I write today to provide the U.S. Army Corps of Engineers with information about water levels of the Savannah River at the Jefferson Davis Bridge, also known as the 5th Street Bridge, at the time of the signing of the Water Infrastructure Improvements for the Nation (WIIN) Act of 2016.

The language of the WIIN Act requires the fish passage structure to “maintain the pool for navigation, water supply, and recreational activities, **as in existence on the date of enactment of this Act**” for either a “repair of the lock wall of the New Savannah Bluff Lock and Dam and modification of the structure” or “removal of the New Savannah Bluff Lock and Dam on completion of construction of the [fish passage] structure.”

USGS 82196670 SAVANNAH RIVER JEFFERSON DAVIS BR, AT AUGUSTA, GA

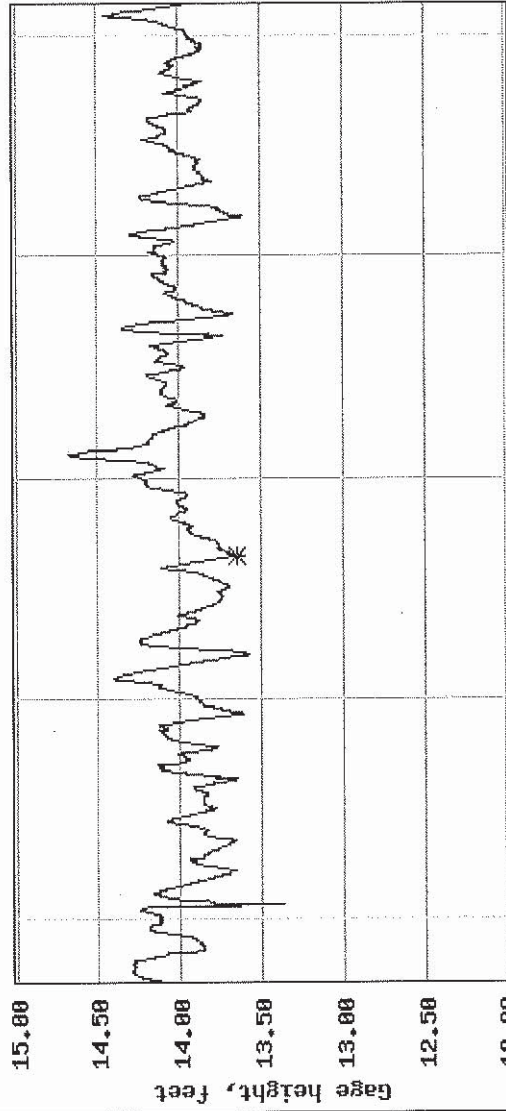
Based on the information from the U.S. Geological Survey, the water level of the Savannah River at the 5th Street Bridge varied between approximately 113.5 feet and 114.5 feet, with the gage height measuring between approximately 13.5 feet and almost 15 feet, in December of 2016, when the WIIN Act was signed into law. It was Congress’ intent that when using the language “as in existence on the date of enactment of this Act,” the water levels on that date should be the marker for what is acceptable when it comes to maintaining the pool level.

The numbers that we have seen from the U.S. Army Corps of Engineers at the 5th Street Bridge are a calculated average depth variation between 10 and 13 feet. Further, in the Draft Recommended Plan that replaces the New Savannah Bluff Lock and Dam with a High Fixed Weir structure with a Dry Floodplain, you calculate the pool will be dropped to approximately 9.5 feet deep, which is below your own numbers of calculated average depth variation between 10 to 13 feet.

Lowering the pool is unacceptable. The language of the WIIN Act clearly states that the water level should be maintained to the level on the date of enactment of this Act, and these numbers provided by the U.S. Geological Survey clearly show that the Draft Recommended Plan does not meet the letter of the law. We respectfully request that you review the enclosed attachments and provide a response to the following questions:

- If you are not using the water levels from the U.S. Geological Survey, can you please provide the source for your numbers and over what time period these numbers were calculated?
- In light of the recorded water levels in December 2016, will the Corps review the options and modify them to ensure the pool level is in compliance with the WIIN Act?
- If the Corps will not modify the options, can you please give a detailed response on why you believe the High Fixed Weir structure with a Dry Floodplain is within the law?
- Since three local governing bodies have endorsed maintaining the pool at an elevation of 114.5 feet, will the Corps choose another option as their Draft Recommended Plan that maintains a higher water level than the current Draft Recommended Plan, which lowers the pool to approximately 9.5 feet?
